TEXAS COMMISSION ON ENVIRONMENTAL QUALITY

ADDENDUM NUMBER 1

SOLICITATION NO. 582-22-30556

**TEXAS VOLKSWAGEN ENVIRONMENTAL MITIGATION PROGRAM (TXVEMP)
LIGHT-DUTY ZERO EMISSION VEHICLES (ZEV) SUPPLY EQUIPMENT DIRECT CURRENT
FAST CHARGERS (DCFC) AND HYDROGEN DISPENSING EQUIPMENT**

2. Section 1.6 ELIGIBLE GRANT AMOUNTS, Item 1, Page No. 3 now reads:

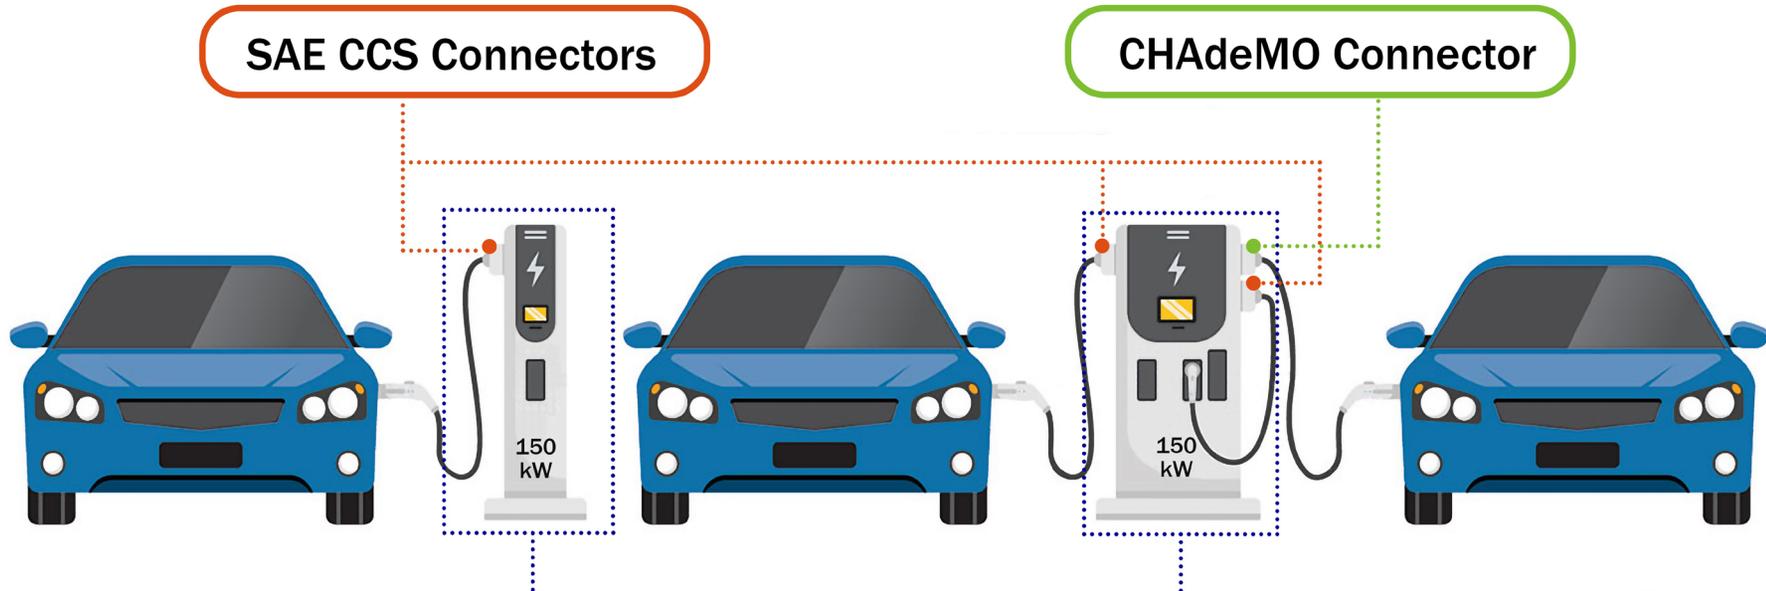
- Each individual charge post/dispensing unit qualifies for up to \$150,000 in grant funds. For multiple charge posts/dispensing units, grantees may receive up to \$600,000 per project site.
